**SECTION 00 91 01
ADDENDUM NUMBER 1**

DATE: AUGUST 22, 2022
PROJECT: KEN PICKERILL HOUSE RENOVATIONS
6350A MINKLER ROAD
YORKVILLE, ILLINOIS 60560
PROJECT NO: 19-429-1250
OWNER: KENDALL COUNTY FOREST PRESERVE DISTRICT
110 W. MADISON STREET
YORKVILLE, ILLINOIS 60560
TO: PROSPECTIVE BIDDERS / PLANHOLDERS OF RECORD

This Addendum consists of Two (2) pages and Drawings A311 & A910.

3.01 DRAWING A311 - CANOPY AND PATIO PLAN

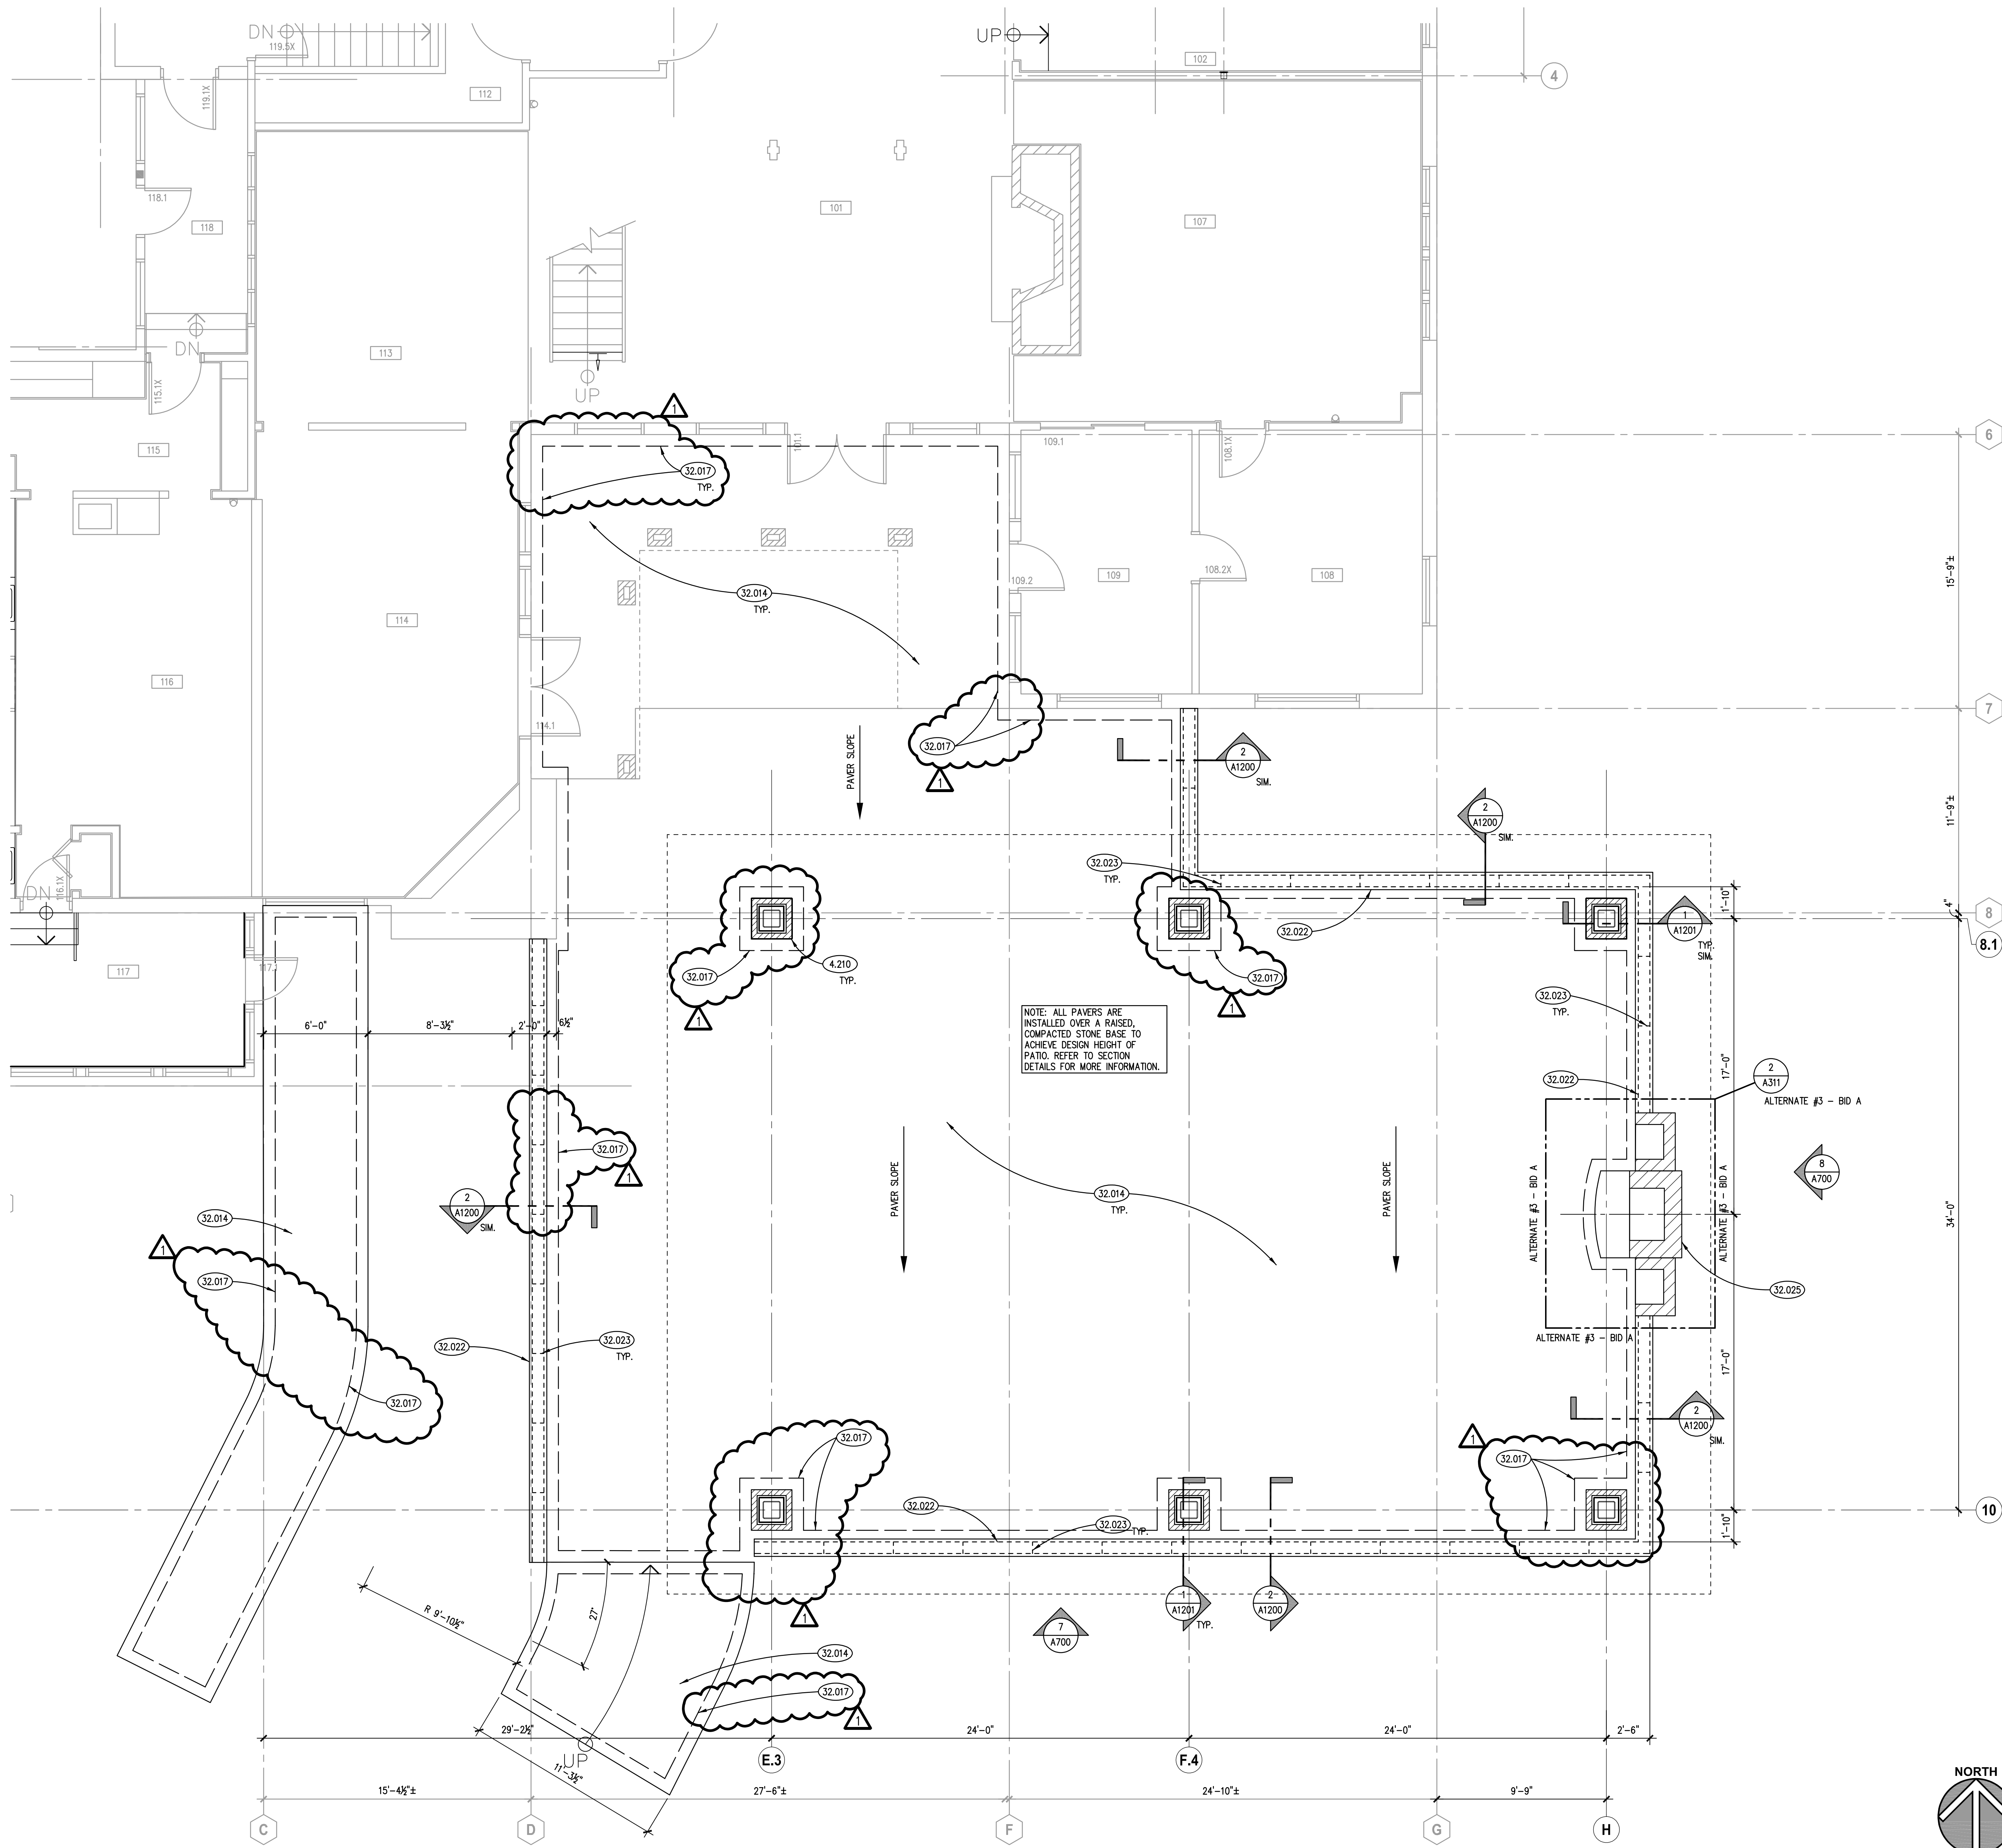
A. Indicated the extent of Precast Concrete Unit Pavers: 8" wide Soldier Border Edging pavers per Keynote 32.017 at the perimeter of the new paver sidewalks, patio and canopy column locations.

B. Revised Keynote 32.014 to note "Field Pavers" in keynote description.

3.02 DRAWING A910 - FIRST FLOOR FINISH PLAN

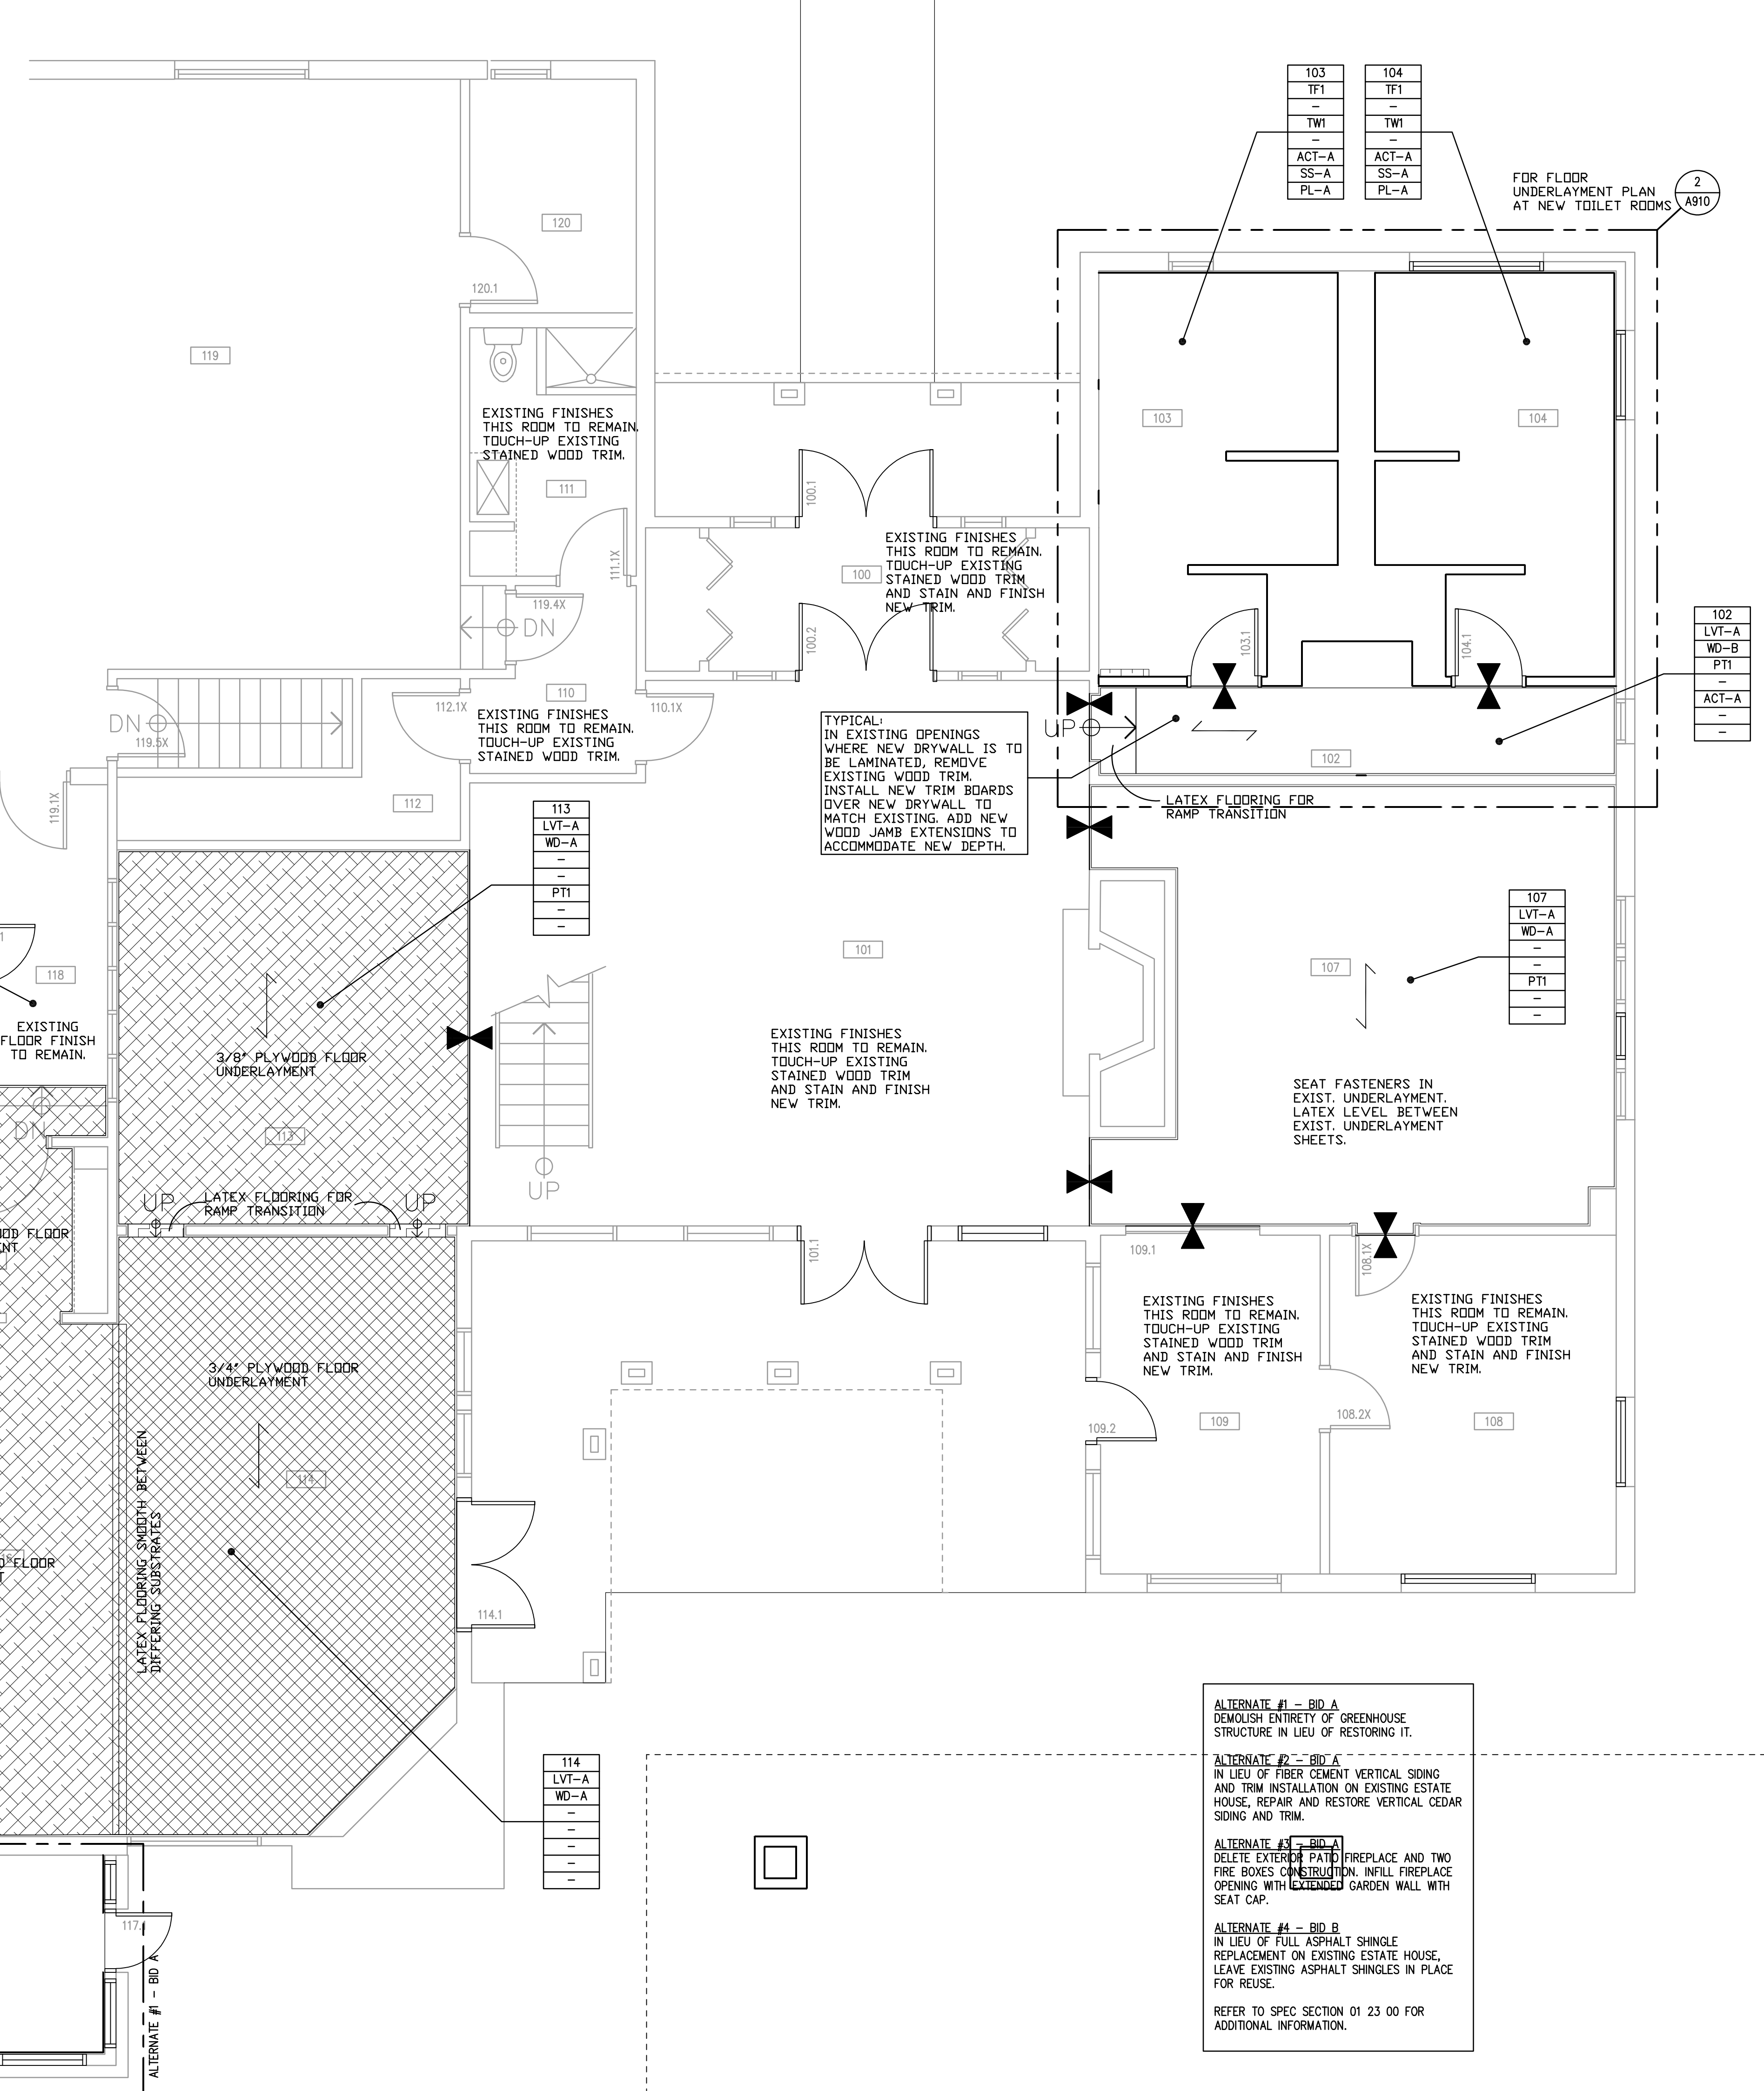
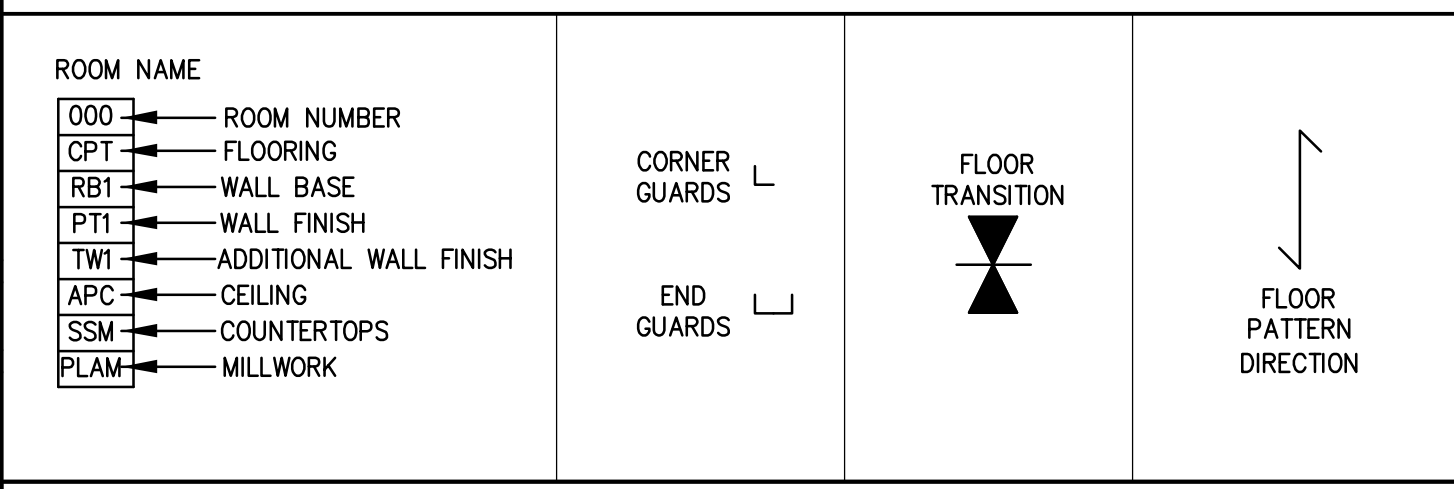
A. Revised FINISHES SCHEDULE for revised Porcelain Tile Flooring (TF1) and Walls (TW1).
